U.S. Department
of Transportation
**Federal Highway
Administration**

March 11, 2008

In Reply Refer To: HSSD/CC-69E

Thank you for your December 14, 2007, letter requesting Federal Highway Administration (FHWA) acceptance of an extension to the Road Systems, Inc., Single Sided Crash Cushion (SSCC) as a test level 3 (TL-3) device for use on the National Highway System (NHS). You requested that we find the extended SSCC acceptable for use on the NHS under the provisions of National Cooperative Highway Research Program (NCHRP) Report 350 "Recommended Procedures for the Safety Performance Evaluation of Highway Features."

SSCC-40 SYSTEM LAYOUT

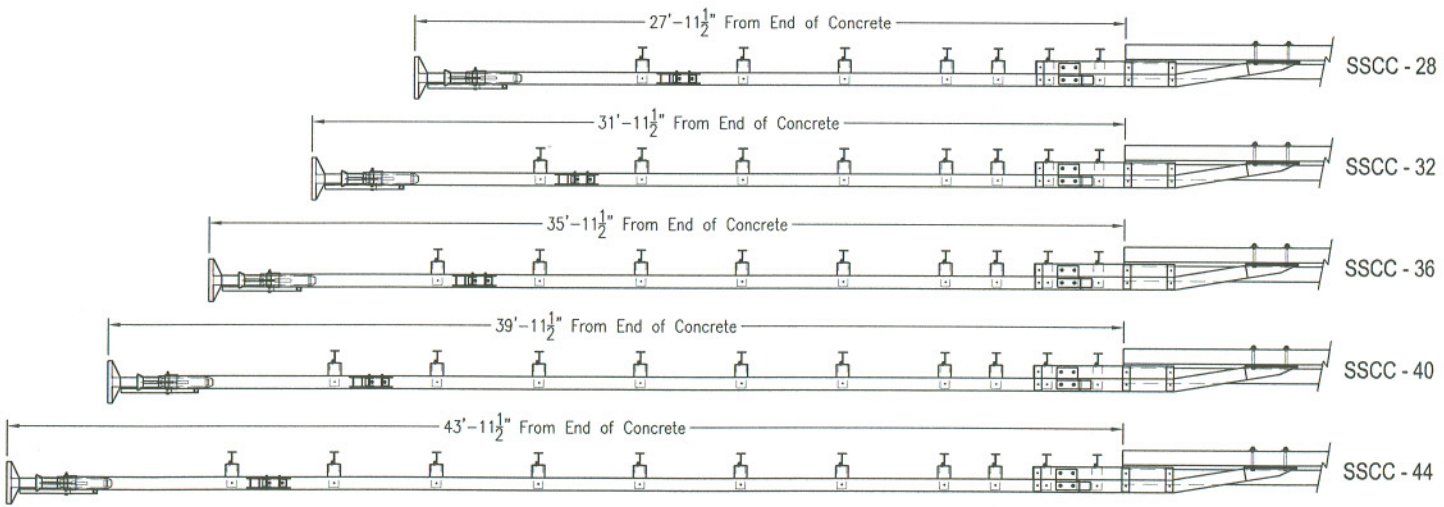
The SSCC was originally accepted by FHWA in 2002 (CC-69B) in a soil mounted configuration and in 2004 (CC-69D) in a pavement mounted option. Both of these designs incorporate a 27 ft – 11.5 inch long design with a total of 8 breakaway posts. The spacing between the first and second post was 6 feet 6 inches. The next three posts were spaced 4 feet apart, and the final three posts were reduced to 2 feet apart. It is proposed that the SSCC be lengthened by incorporating additional box beam railing in the 4 foot post spacing region. As shown on the enclosed drawing, extensions of 4, 8, 12, and 16 feet are proposed.

No additional testing was conducted on the extended SSCC. You claim that the modification would have no adverse effect on the performance of the SSCC. You enumerated the various crash tests that are required for a barrier terminal:

Test 30, Test 31, Test 32, Test 33 all involve end-on impacts. As the proposed change extends the second stage energy absorber, the only effect would be to increase the terminal's energy dissipation capacity for end-on impacts.

Test 34 and Test 35 involve impacts on the side. As the proposed extension does not introduce components that would change the terminal's redirective capacity, there is no need to run either test.

Test 39 is a reverse direction test. As was the case for the same-direction side impacts discussed above, no new design elements are introduced to alter the redirection capability of the device.

We concur in your claim that the optional extension of the SSCC would not adversely affect the crashworthy performance of the device. Therefore, the requested modification is acceptable for use on the NHS, when permitted by a highway or transportation authority, under the range of conditions the original design was tested.
